FCC CLASS II PERMISSIVE CHANGE REQUEST LETTER

RE: FCC Permissive II Change Request for Company: Lightcomm Technology Co.,Ltd.
FCC ID: Y34-UITBSM

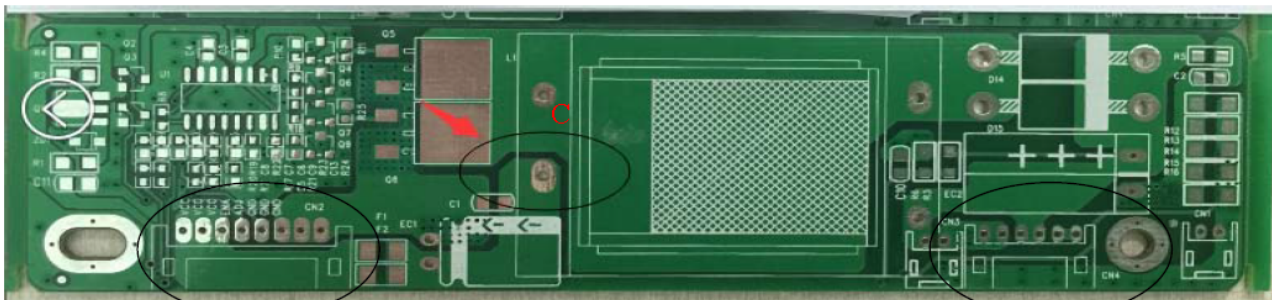
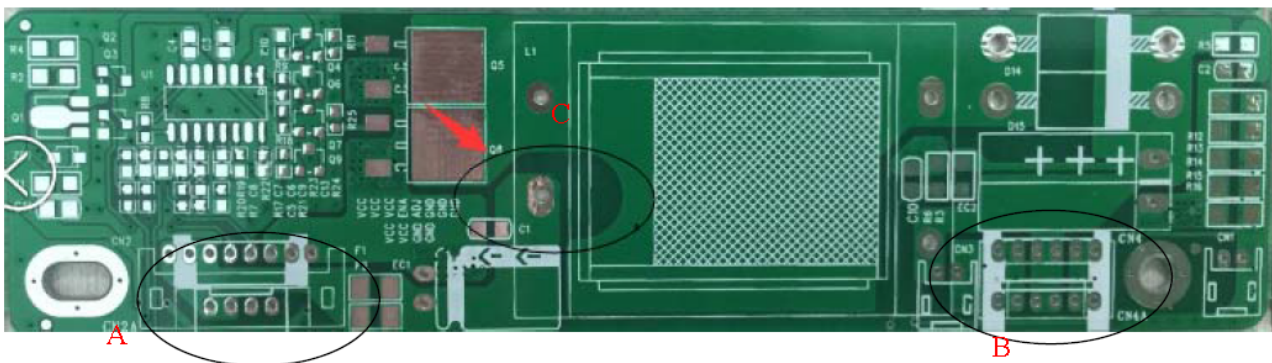
We are submitting an application for a class II permissive change to the FCC approval of the Company name: Outform Ltd, product description: MID (FCC: Y34-UITBSM, Original Grant Date: Nov. 04, 2015). The transmitter module itself has not changed. The LED drives board has changed version number from V1.1 to V1.3, here are the changes:

A: add CN2A/PH2.0 * 4 pin DC input socket

B: add CN4A/PH2.0 * 6 pin backlit output socket

C: Increases the distance L1 inductance between PIN4 feet square copper foil and copper foil, in order to prevent the L1 - PIN4 short-circuit
